RE: Hartman Park Foundation Review  
GEOMAT Project No. 244-4807

As per your request, GEOMAT has reviewed the proposed drilled pier foundation designed by the Sadler Group sealed and dated 2/13/24 using the information GEOMAT provided in the attached geotechnical report for the Williams Arroyo Gabion Wall Repair Project #232-4570 dated October 30, 2023. Two of the proposed lights are located in the vicinity of Bores B-1 and B-2 from the referenced report. Loads and reactions provided by the Sadler Group were utilized for the review.

**PROJECT:**  
 HARTMAN SOCCER FIELDS  
 W. AZTEC BOULEVARD  
 AZTEC, NM 87410

**PRODUCT:**  
 LIGHT POLES PIERS

PROJECT NO. 24-109	DATE: 02-13-2024	DRAWN BY: VNR	SHEET NO. S1
-----------------------	---------------------	------------------	-----------------

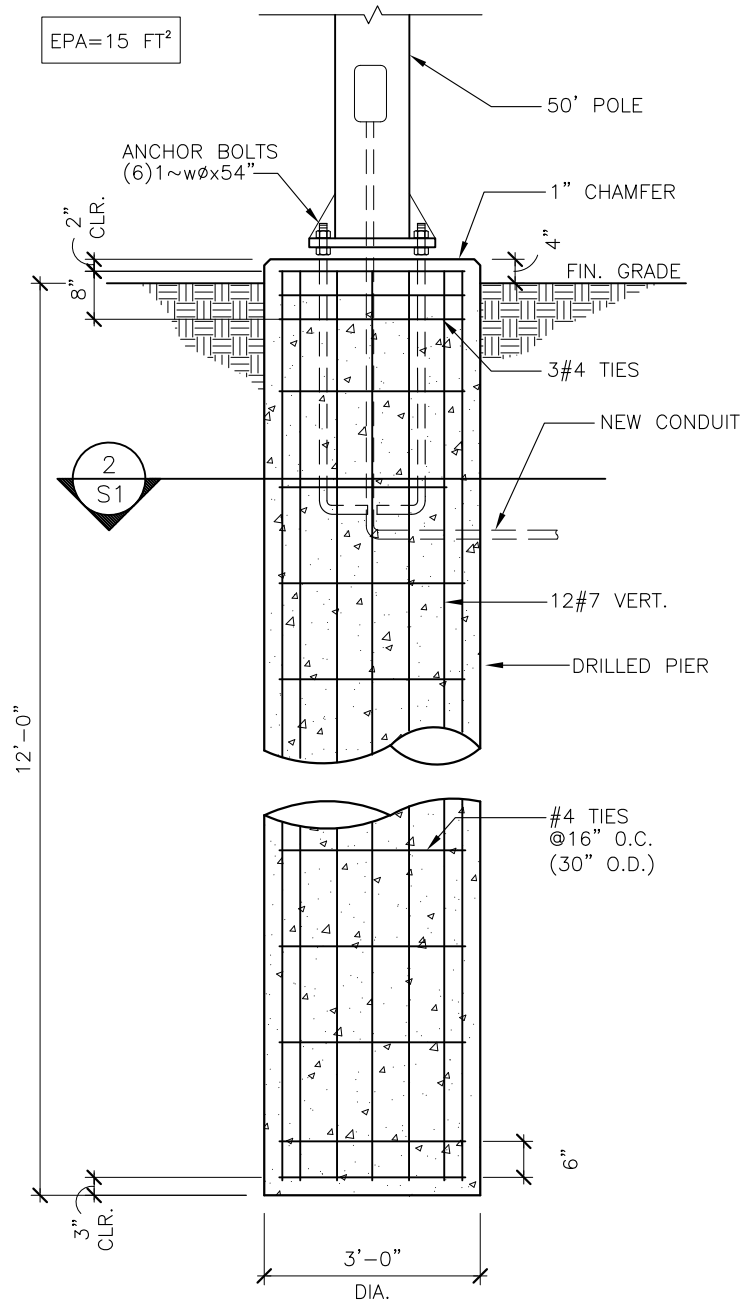
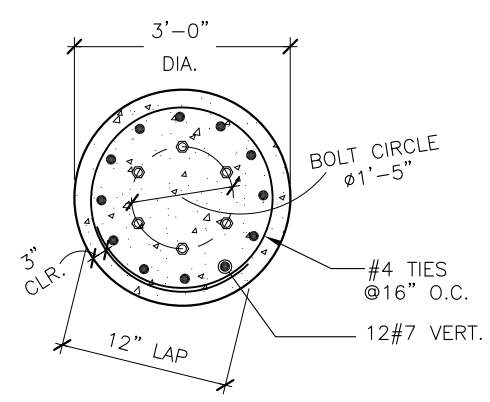
Based upon our analysis, it was determined that the foundations as designed by the Sadler Group will be satisfactory based upon the conditions encountered in our borings. For our analysis, we assumed that the gabion slope stabilization will be in place to resist potential blowout and scouring. We further recommend that the lights/foundations should be constructed no closer than ten (10.0) feet from the back face of the gabion retaining wall. It is assumed if there is geofabric designed for the proposed gabion wall, it could potentially be located and interfere with the location at which the light/foundation is proposed. Construction and placement of the geofabric shall follow manufacturer's recommendation when there are obstructions and penetrations in the geofabric.

Based upon the boring data, it should be anticipated that soft, wet soils and potentially groundwater will be encountered. If caving occurs or "slough" from the surface falls into the borehole after placement of the reinforcement cage, the reinforcement cage shall be removed, the bottom cleaned out, and reinforcement cage reinserted. The use of drilling slurry or casing may be required should groundwater be encountered. Tremie methods of concrete placement as described below may aid in constructing the shaft.

- Drilled shafts shall be cleaned with a clean-out bucket, immediately before concrete placement.
- The tremie or pump pipe shall have watertight joints.
- During the initial concrete placement, the concrete tremie or pump pipe shall be extended to the bottom of the drilled shaft before concrete placement.

- During placement of concrete, the bottom of the pipe shall be maintained below the top of the concrete at all times. If the seal is lost, the pipe shall be re-inserted, and the operation restarted.
- Sufficient embedment of the tremie or pump pipe in concrete shall be maintained throughout concrete placement to prevent re-entry of water. The minimum embedment depth shall be 5 feet.
- The first-placed portion of concrete flow that comes to the top of the shaft shall be wasted, as determined by the Geotechnical Engineer.
- Under no circumstances shall concrete be allowed to free fall through water or drilling fluid.
